AGENDA FOR THE REGULAR MEETING OF THE
MIDWEST CITY
PLANNING COMMISSION
April 6, 2021 – 6:00 p.m.
City Council Chambers
City Hall
100 North Midwest Boulevard

Subject: (PC – 2075) Discussion and consideration of approval of the Replat of Lots 1-5 of Block 2 of the Radford Addition, described as a part of the NW/4 of Section 35, T12N, R2W and addressed as 8708 NE 5th Street.

Subject: Engineering staff comments for pc-2075 re-plat application

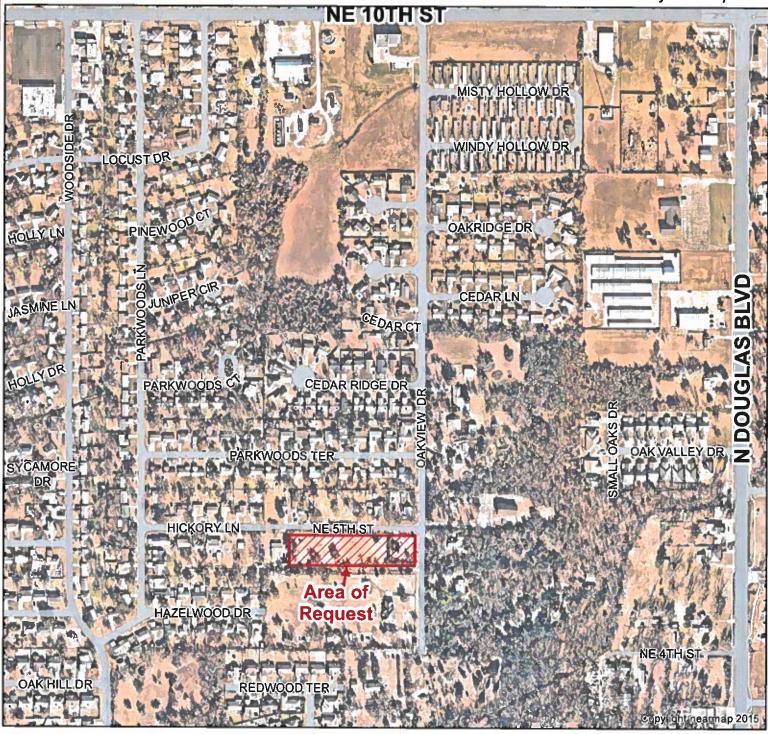
Looking west from western edge of subject plat. Shows NE 5th Street in a city standard configuration. Concrete with curb and gutter on both sides and sidewalk
